<b>Docket Number:</b>	09-AFC-07C
<b>Project Title:</b>	Palen Solar Power Project - Compliance
<b>TN #:</b>	203109
<b>Document Title:</b>	Pat Flanagan Comments: Project description invalid: CEC approval would be illegal
<b>Description:</b>	N/A
<b>Filer:</b>	System
<b>Organization:</b>	Morongo Basin Conservation Association/ Pat Flanagan
<b>Submitter Role:</b>	Public
<b>Submission Date:</b>	9/26/2014 9:01:10 AM
<b>Docketed Date:</b>	9/26/2014

**Project description invalid: CEC approval would be illegal**

Subject: Palen Solar Energy Generating System Docket No. 09-AFC-07C  
Project Description Invalid: CEC approval would be illegal

**Figure 1 – Visualization showing the difference between the BLM DEIS and the CEC FSA**

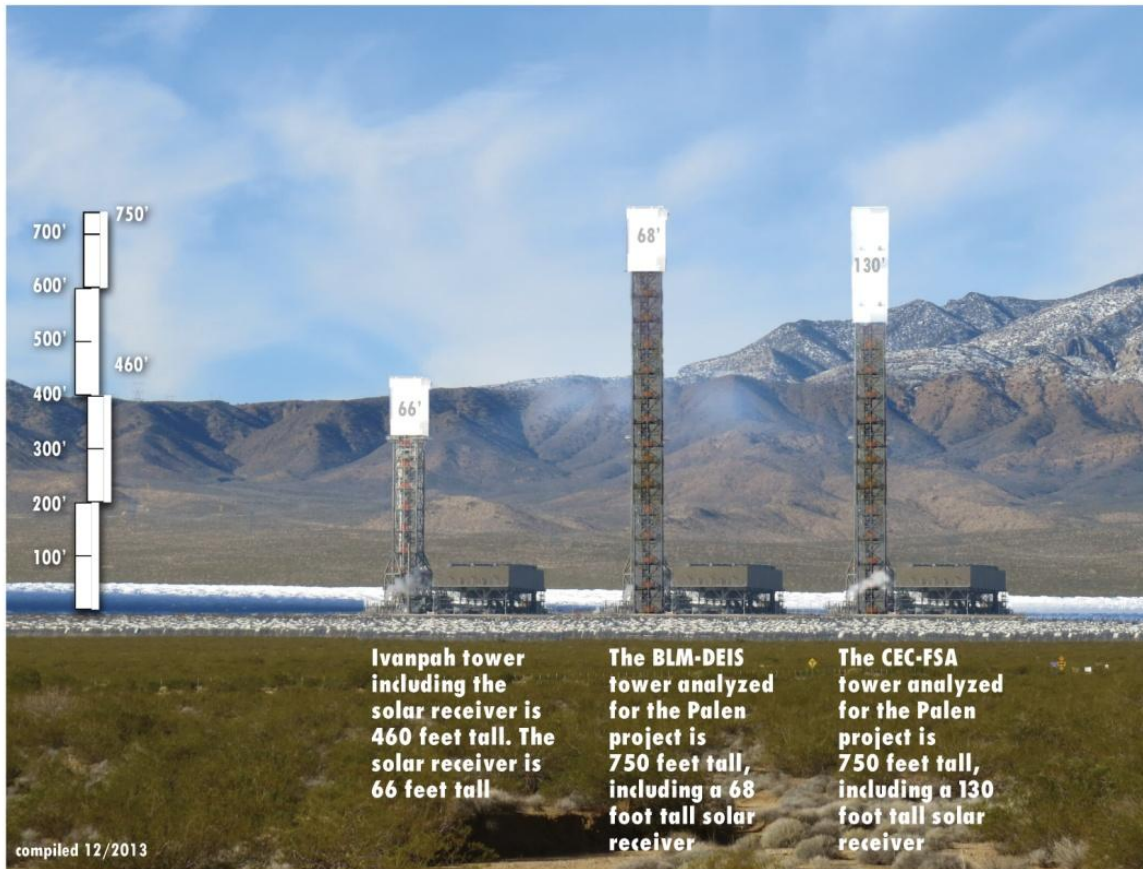
In past correspondence I have also brought to your attention the differences between the CEC tower/receiver dimensions and the BLM as analyzed in the DEIS.<sup>2</sup> I continue to inquire: which of the projects is correct and which project will be built? There has been no update on this problem. CEQA and NEPA are required to match.

Document	Tower /feet	Location	SRSR/feet	Total Height	Reference
CEC Documents	620	Topped by	130	750	PA, PSA, PMPD, RPMPD
BLM-DEIS	750	Including	68	750	Page 4.18-7 (7/2013)

<sup>2</sup> See Figure 1: Visualization of the inconsistency between the BLM DEIS and the CEC FSA
